The
WHITE PINE
SERIES OF
Architectural Monographs
Volume VII **Number 4**

Designs for a
THREE TEACHER
RURAL SCHOOL
With Teachers' Cottage

A THREE-TEACHER RURAL SCHOOL WITH TEACHERS' COTTAGE

REPORT OF THE JURY OF AWARD OF THE SIXTH ANNUAL WHITE PINE ARCHITECTURAL COMPETITION

MENTION, Detail Sheet
Submitted by Leon H. Hoag, Bloomfield, N. J.

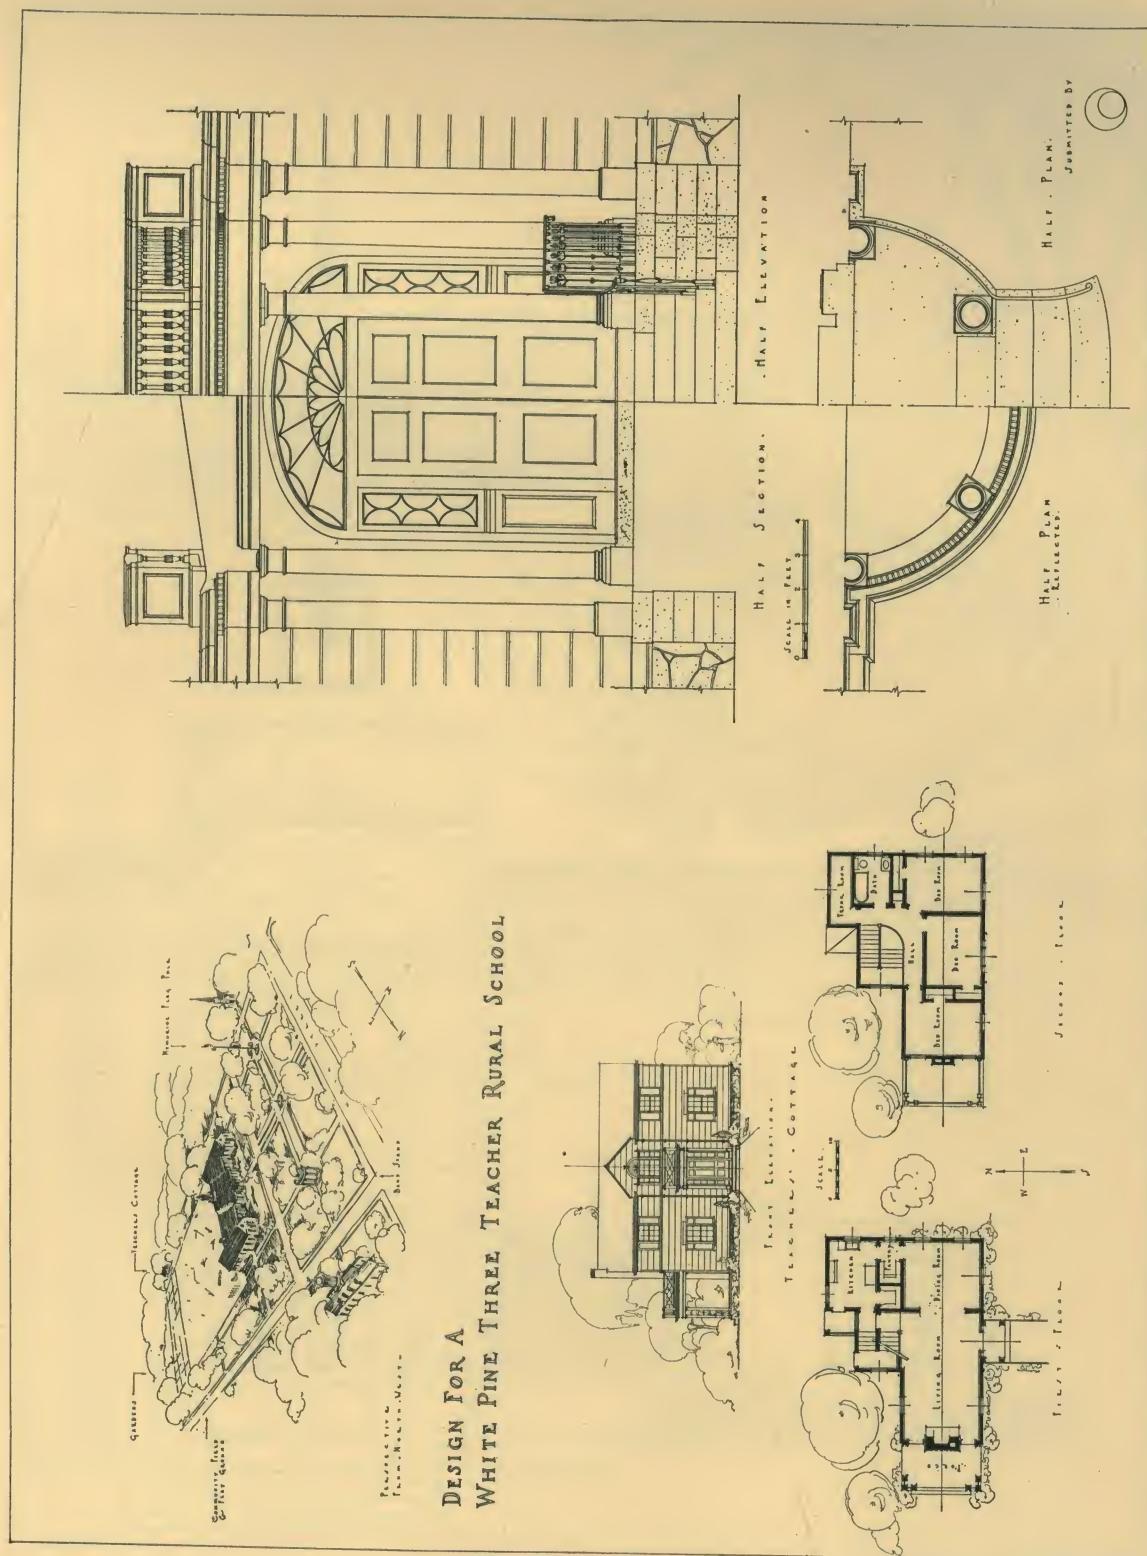
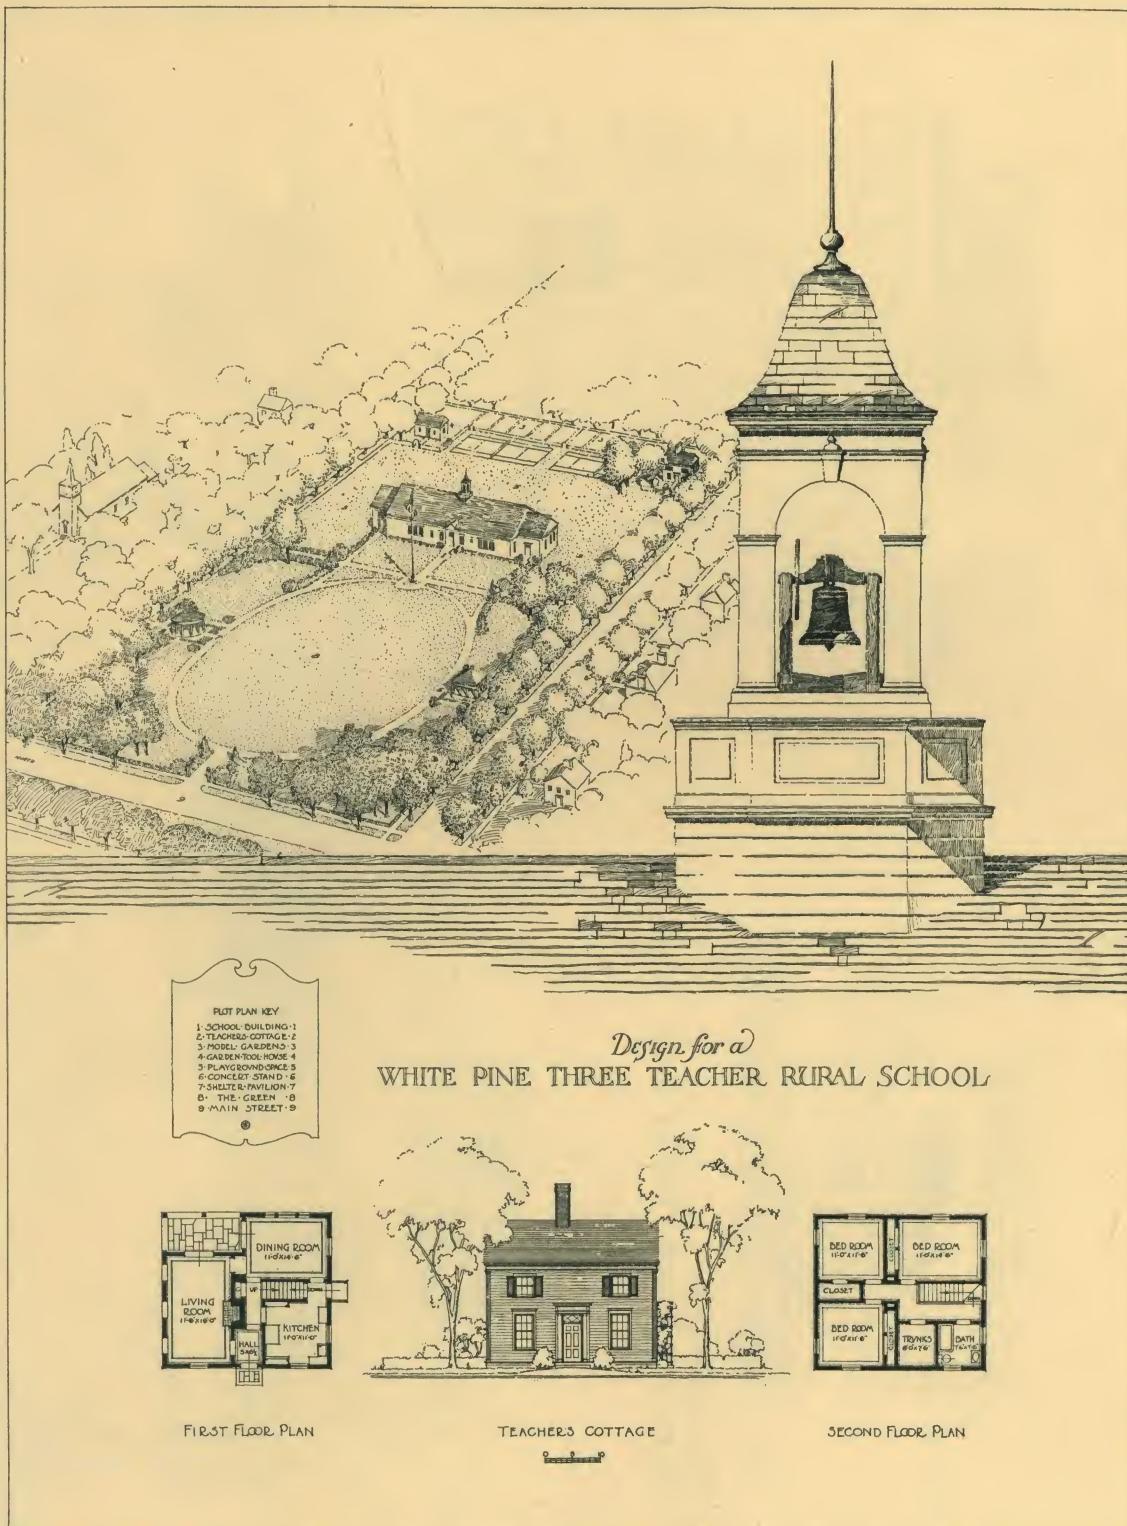
exterior well balanced, but not too replete with points of interest. Mr. Leon H. Hoag's design, concluding the list of those to receive mention, has many good points in plan, together with an exterior which would have been much more attractive and effective had its rather ænemic porch been made to hold its own with the unnecessarily expansive grouped windows of the corridor.

MENTION, Detail Sheet
Submitted by Paul Hyde Harbach, Buffalo, N. Y.

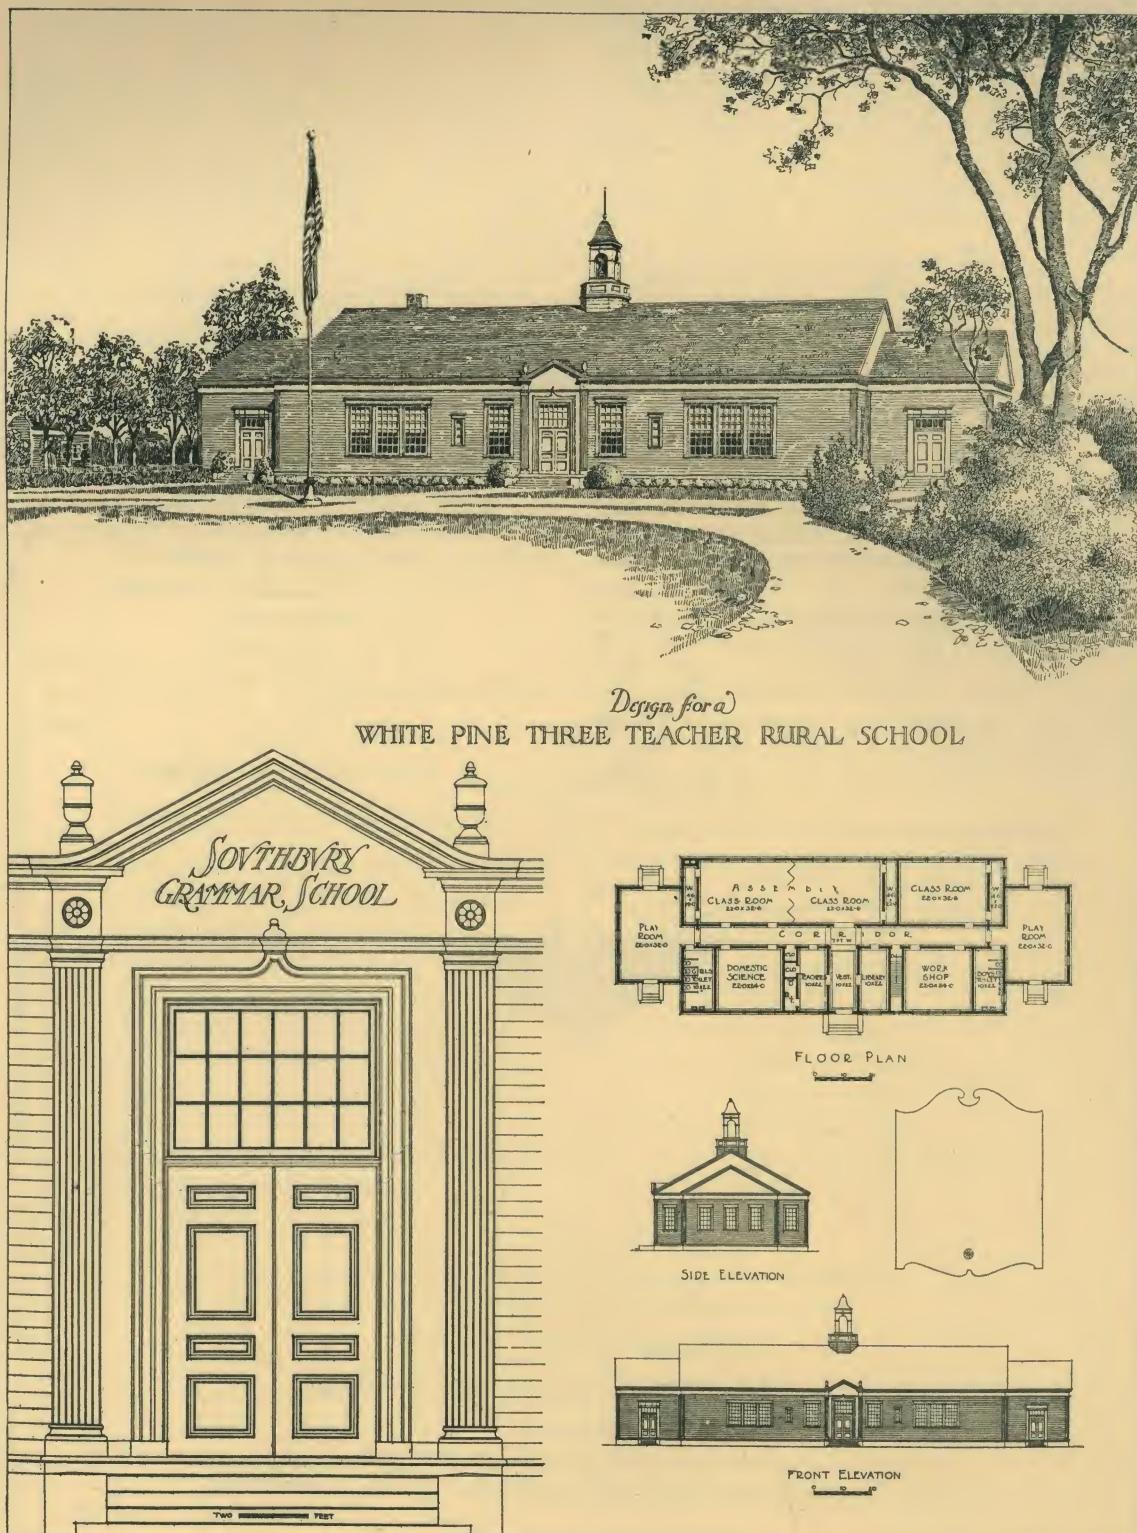
The design submitted by Messrs. Dornbusch and Kaeyer, while extremely attractive in its terraced approaches, suffers from a lack of relationship between the wings, and a central feature which is attenuated and inadequate. The corridor is satisfying. Mr. Harbach's design is good of its type, with a well considered plan, and an
